PRELIMINARY DRAINAGE REPORT

for
HAVEN VALLEY

EL PASO COUNTY PCD FILE NO. PUDSP-21-007

Drexel, Barrell & Co.

Figure 7-9. Street Capacity Charts Minor Residential (Attached Sidewalk)

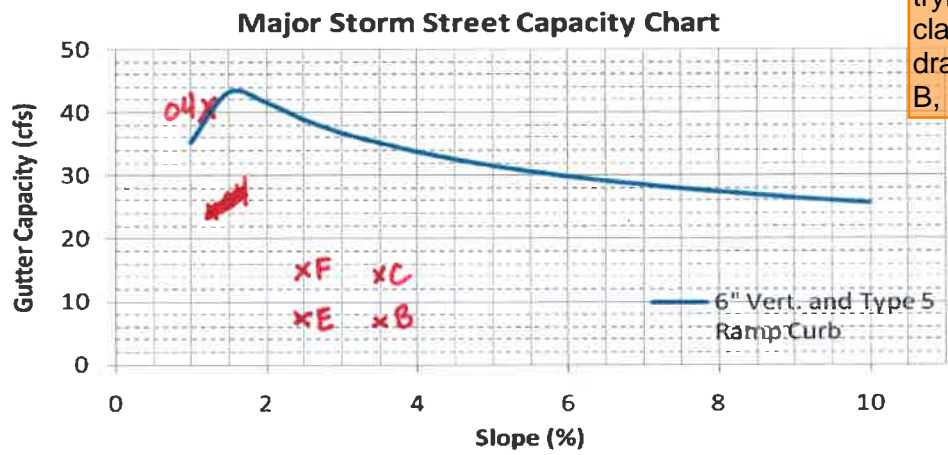
There are not any proposed DP's with letters, so I'm not understanding what you are trying to label. Please clarify. The existing drainage map has DP's A, B, and C, but no E or F...

EXISTING
CONDITIONS
DRAINAGE PLAN

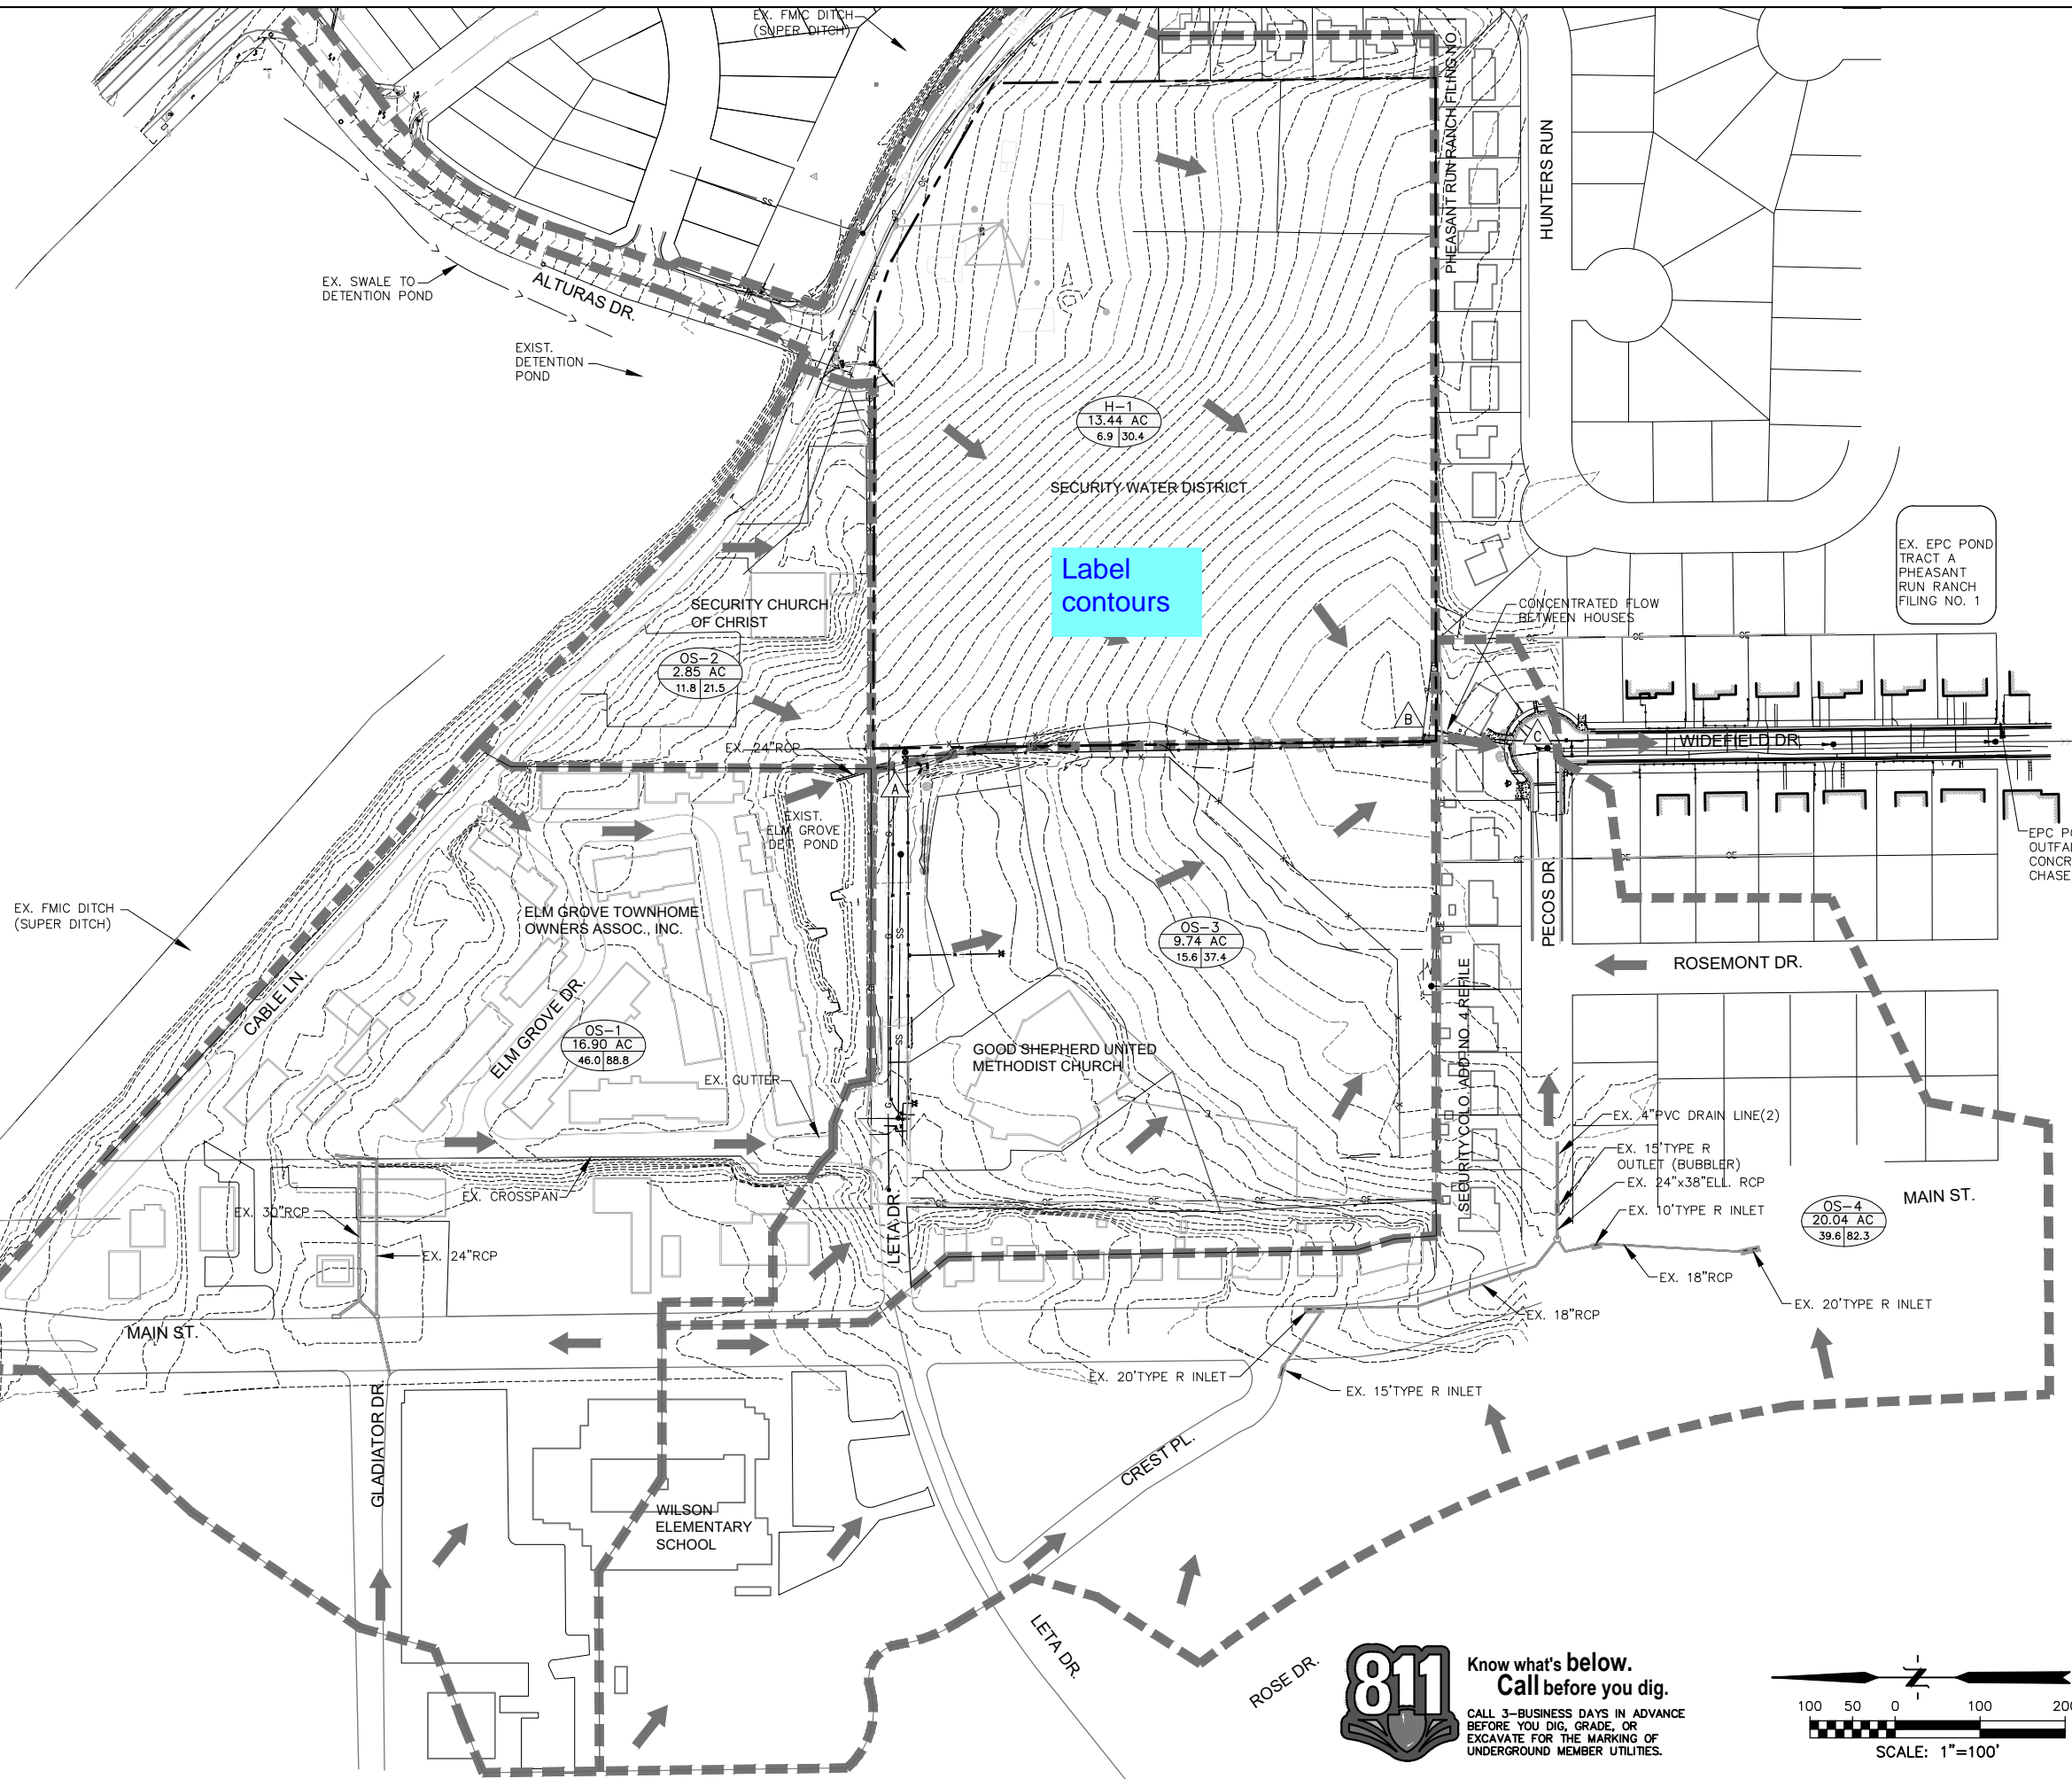
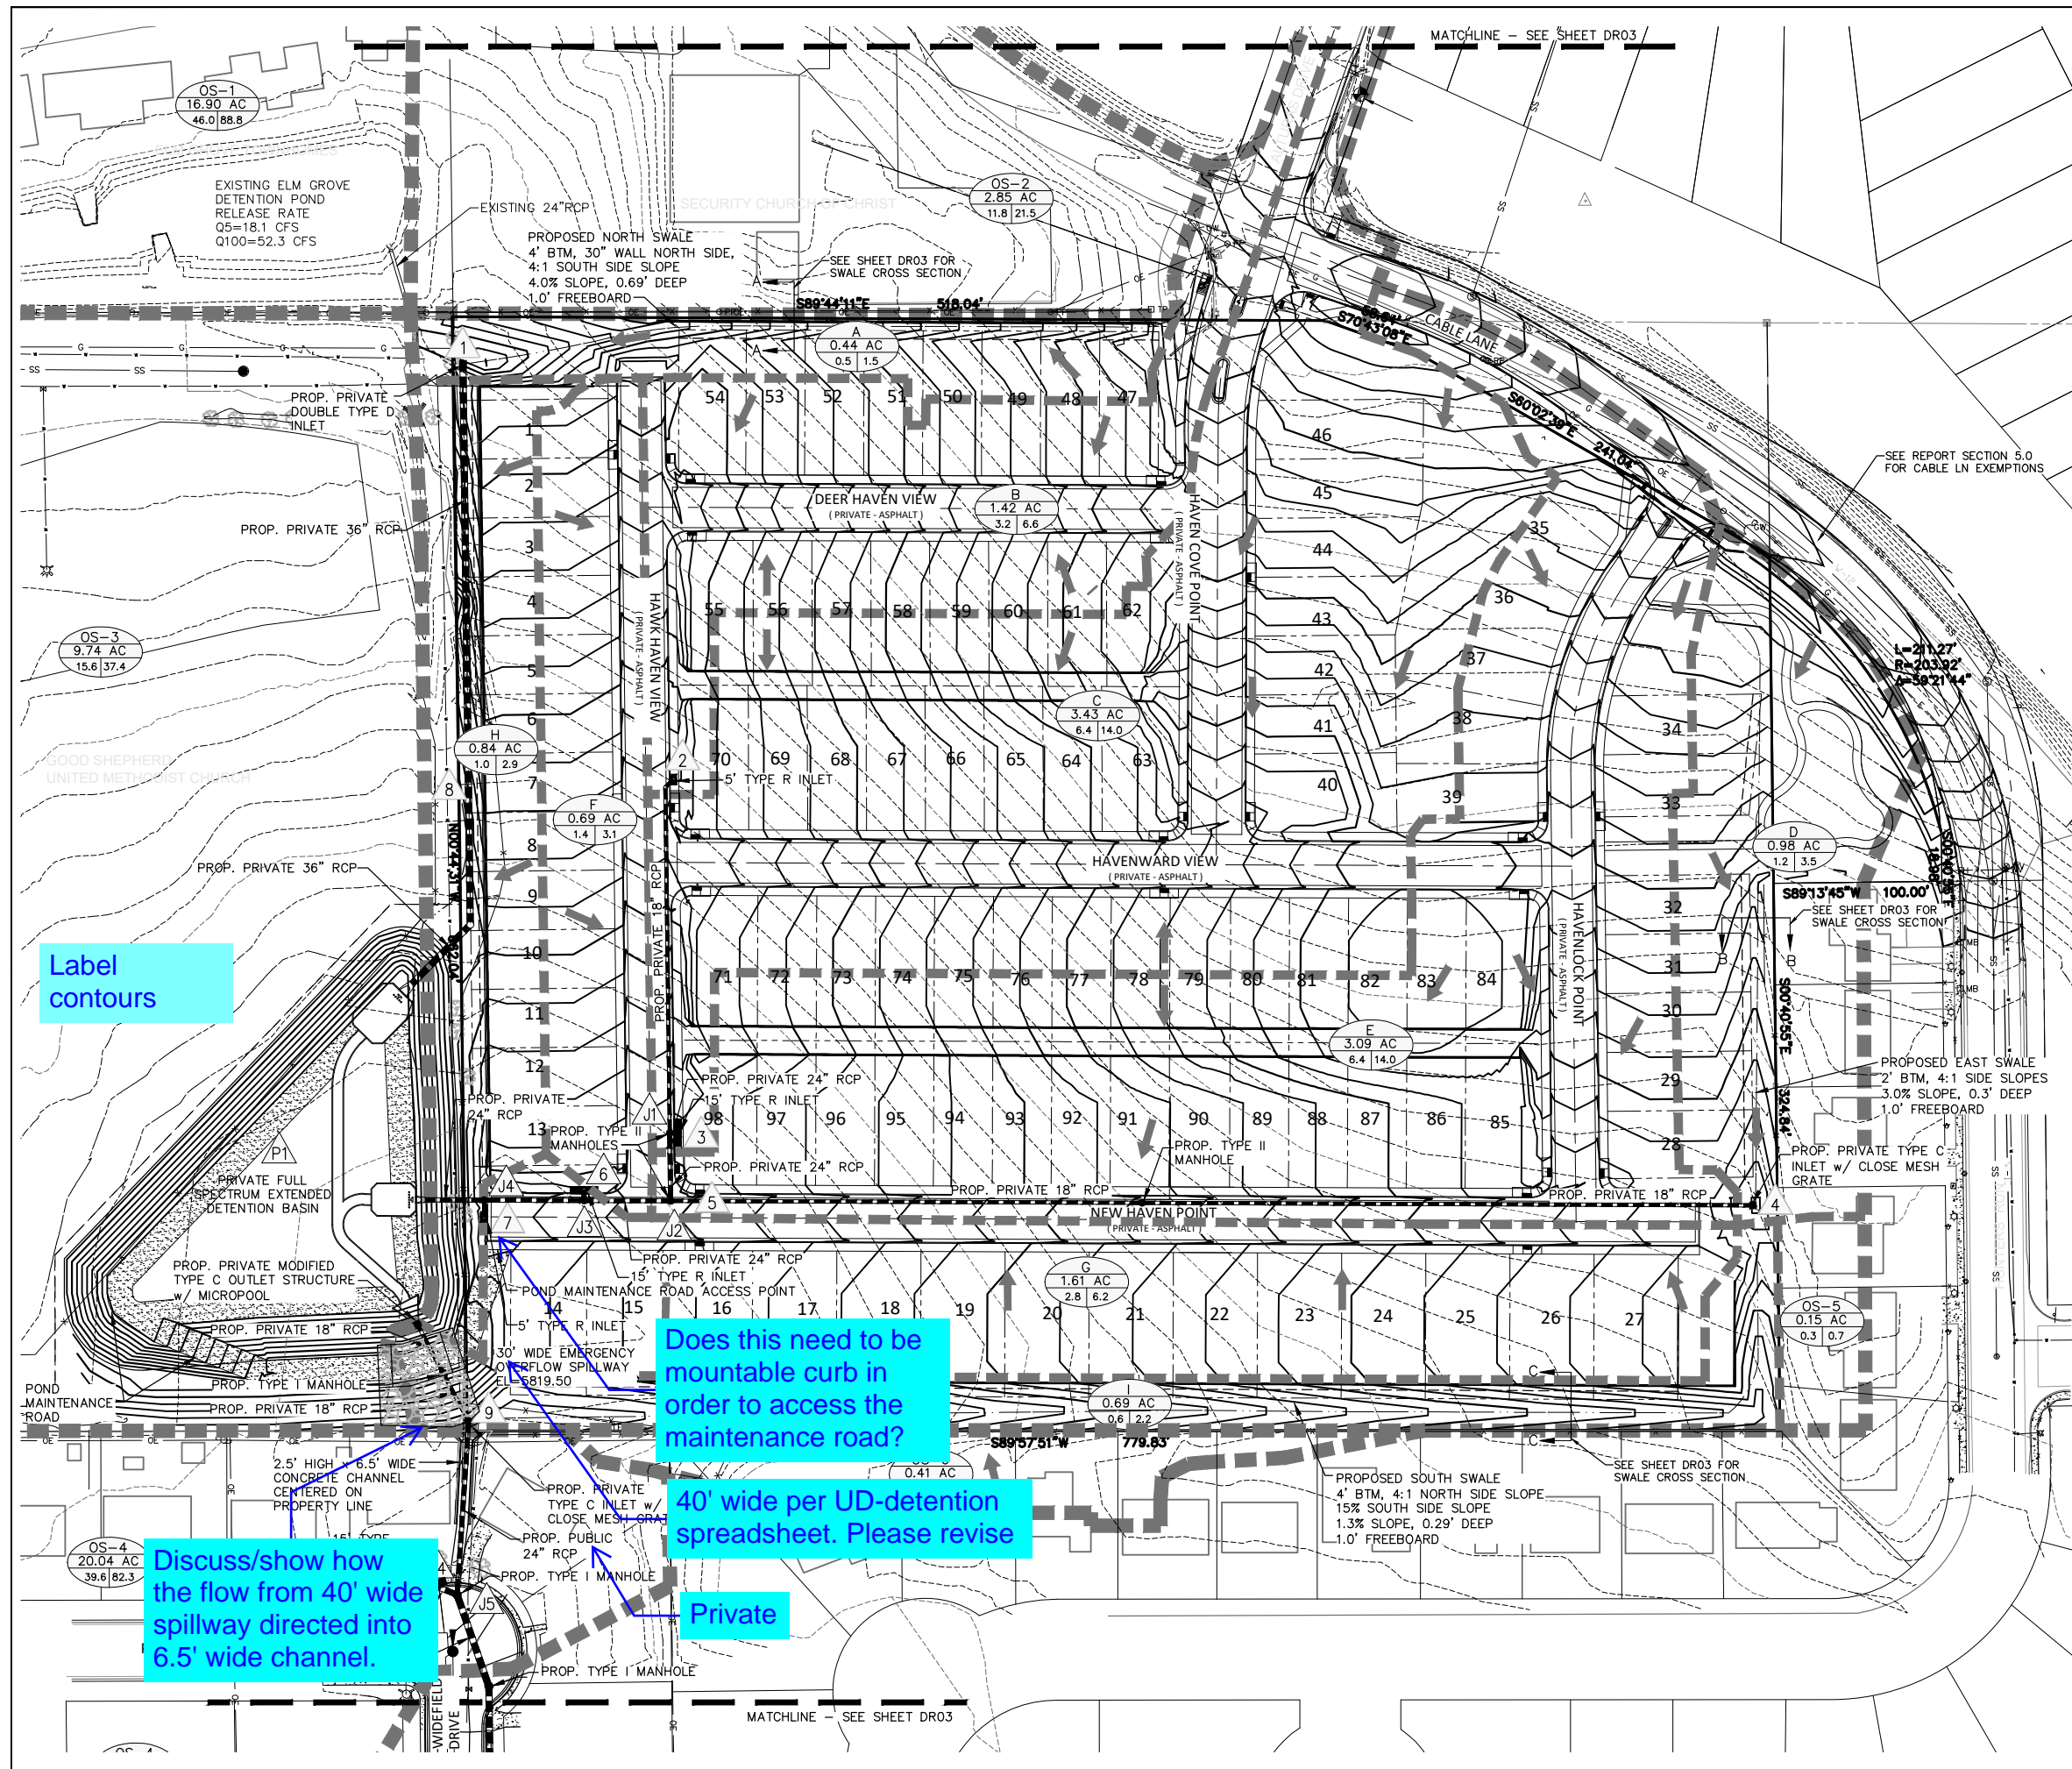
Label contours

PROPOSED CONDITIONS DRAINAGE PLAN

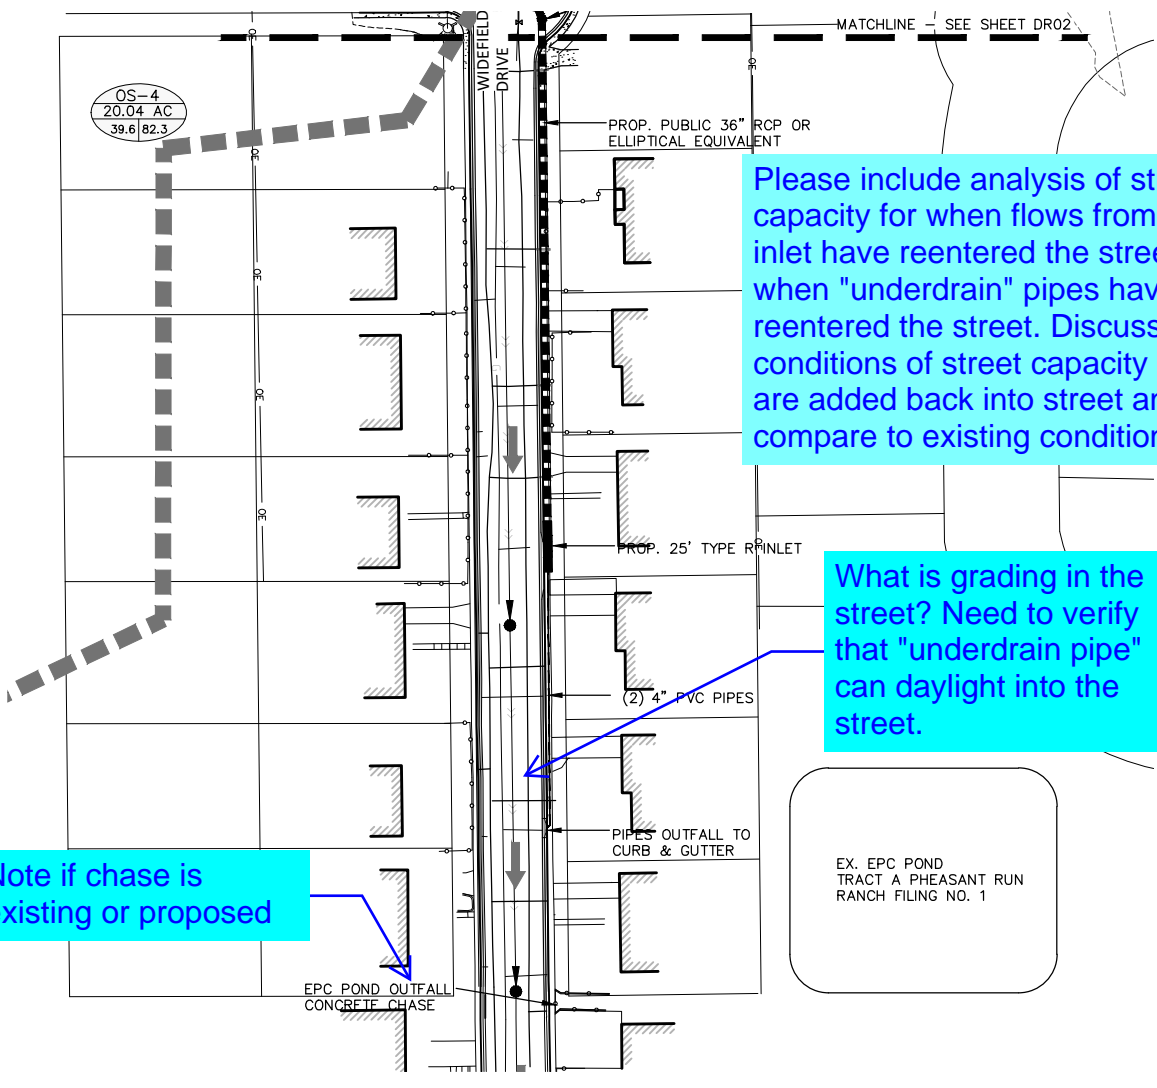
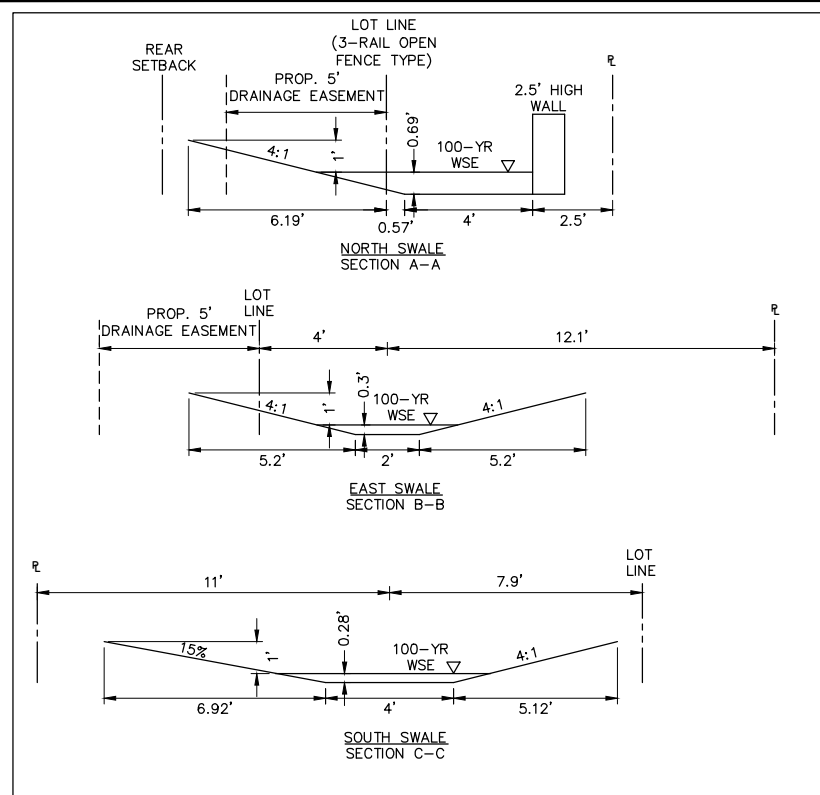
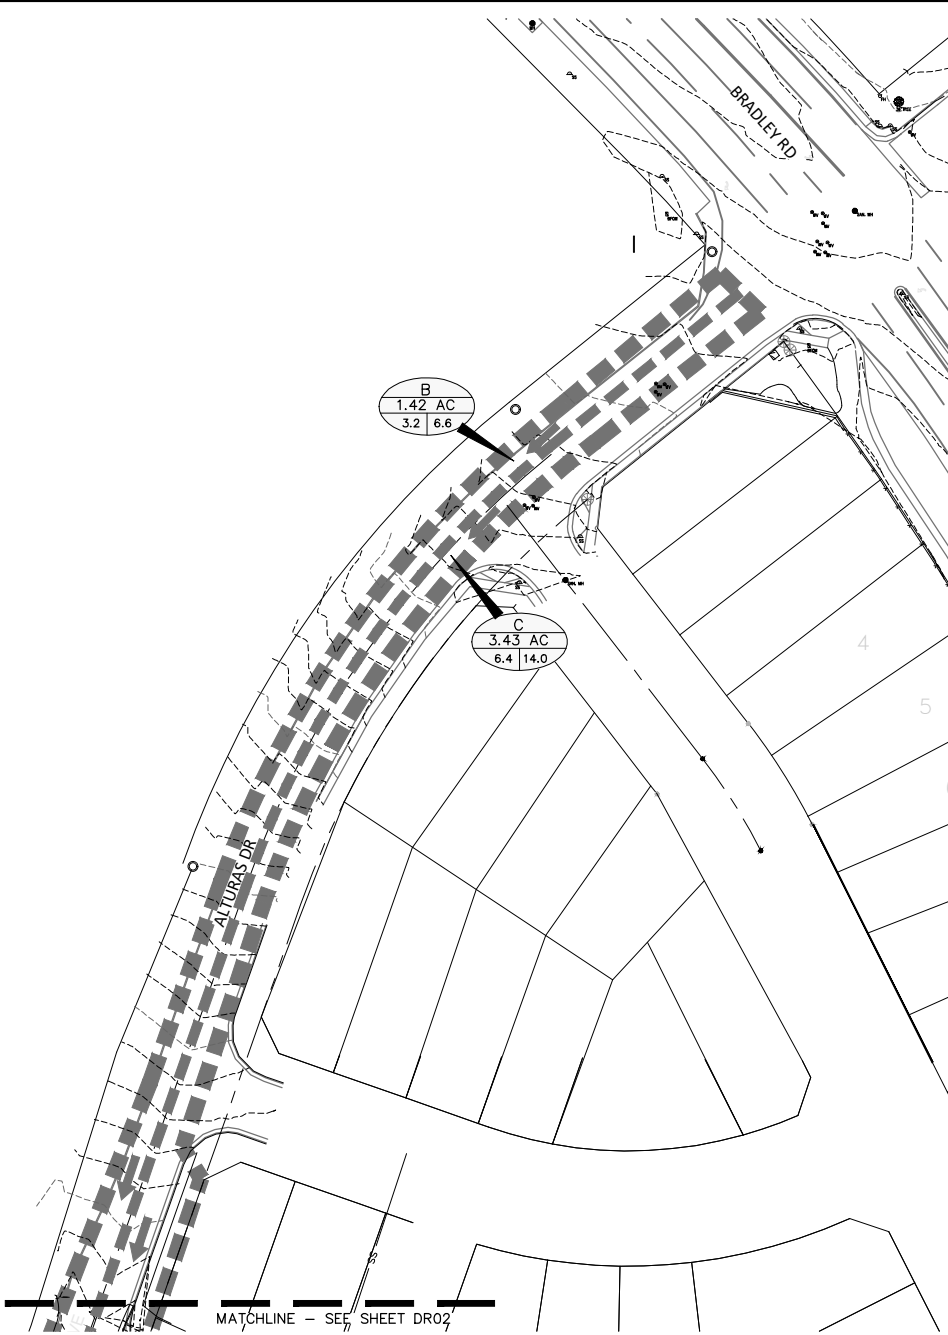
Please include analysis of street capacity for when flows from bubbler inlet have reentered the street and when "underdrain" pipes have reentered the street. Discuss conditions of street capacity as flows are added back into street and compare to existing conditions.

What is grading in the street? Need to verify that "underdrain pipe" can daylight into the street.

Note if chase is existing or proposed
